VALUE ENGINEERING CHANGE PROPOSAL MISSOURI DEPARTMENT OF TRANSPORTATION

Contract ID 120629-C01 Job No. J4I1690

The change proposal is on the details to the proposed box connector and west box extension on culvert number L04802/K01061. We would like to tie to the existing exterior wings at each location and locate the transverse joints at the ends of the existing endsection. This would eliminate the need for the temporary shoring and still meet the requirements of the transverse joint locations according to MoDOT Standard Plans. This proposal will provide a product of equal quality that reduces the project cost. Advantages include the elimination of safety risks associated with shoring and a decrease in overall exposure to the travelling public.

PHILLIPS GRADING AND CONSTRUCTION
CULVERT WALL EXTENSION
FLINTLOCK ROAD
Elevations/Details

DWG. S100
SHT. 1 OF 1

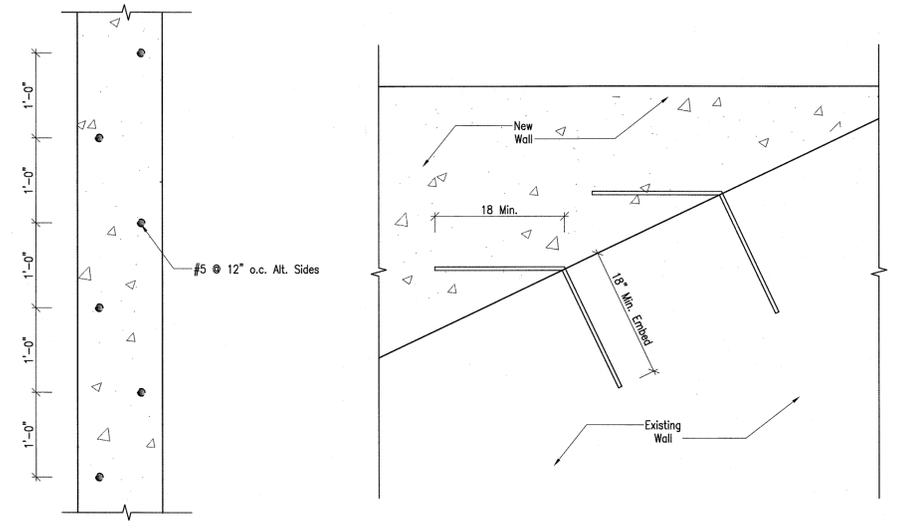
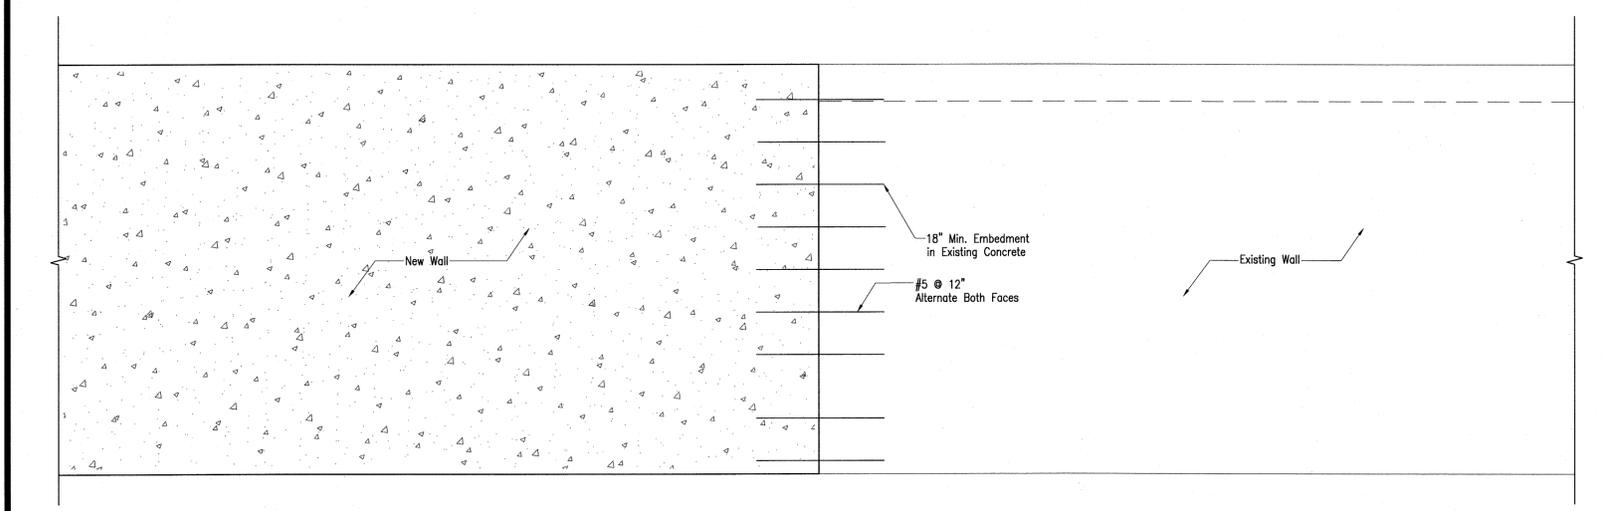
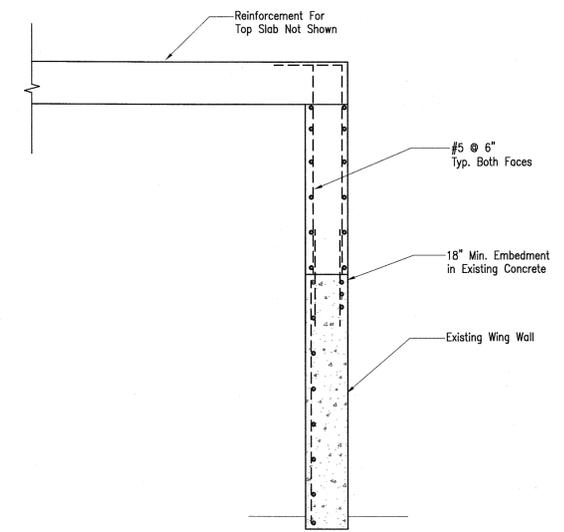
The plan to tie together these boxes and extend the west end in the manner detailed in the VE Proposal would save approximately 90 yards of concrete and 15,918 lbs. of steel.

After review of the information provided, I recommend approval of the suggested work. Contractor addressed comments from the conceptual VE. This included providing detailed drawings and design calculations, signed and stamped by a Licensed PE. A cost breakdown was also requested and provided, which shows the total cost savings.

I concur with the recommendation of the RE. The submittal has all supporting information to substantiate the proposal.

① Modification of Box Connector: LØ48Ø2 / KØ1Ø61
REFERENCE PLAN SHEETS 176 & 177

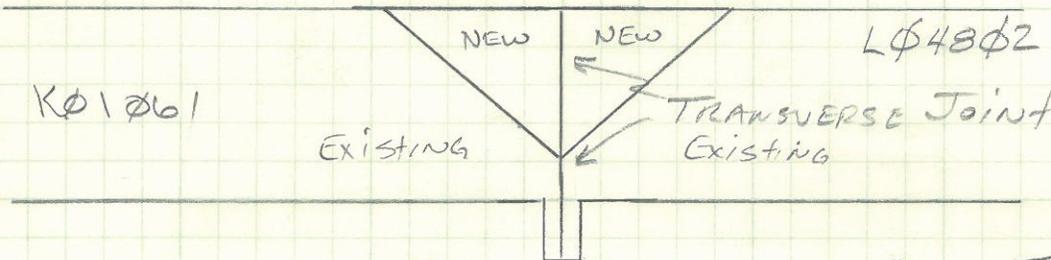
EXTERIOR WING WALLS TO REMAIN
MAKE FULL DEPTH CUTS IN EXISTING STRUCTURE.
FIELD DRILL HOLES TO ANCHOR REINFORCING STEEL INTO
EXISTING. NEW STEEL PER STANDARD PLANS.

EXTEND EXISTING WING WALLS + POUR TOP

ALL STEEL PER STANDARD PLANS.

② MODIFICATION OF BOX EXTENSION: L ϕ 48 ϕ R
REFERENCE PLAN SHEETS 176 & 177

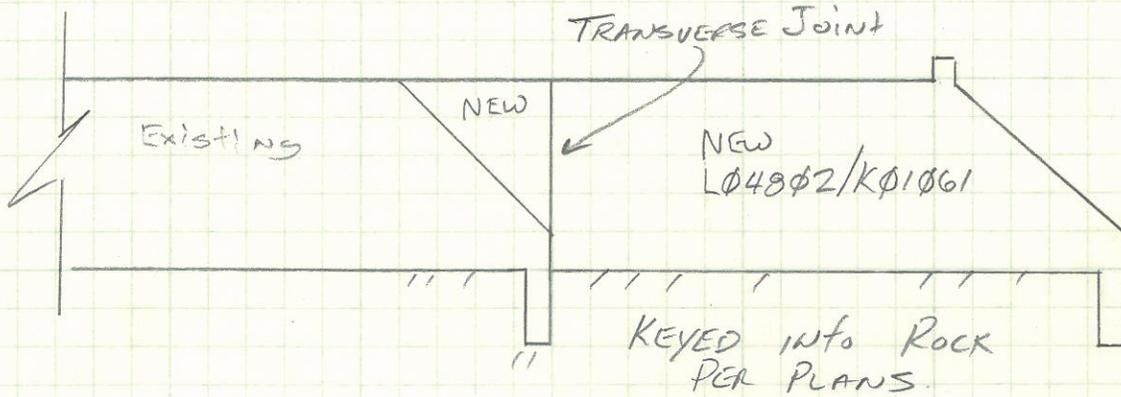
MAKE FULL DEPTH CUTS IN EXISTING STRUCTURE. FIELD DRILL HOLES TO ANCHOR REINFORCING STEEL INTO EXISTING STRUCTURE. ALL NEW STEEL PER STANDARD PLANS.

EXTEND EXISTING WING WALLS & POUR TOP TO THE LIMITS OF NEW TRANSVERSE JOINT.
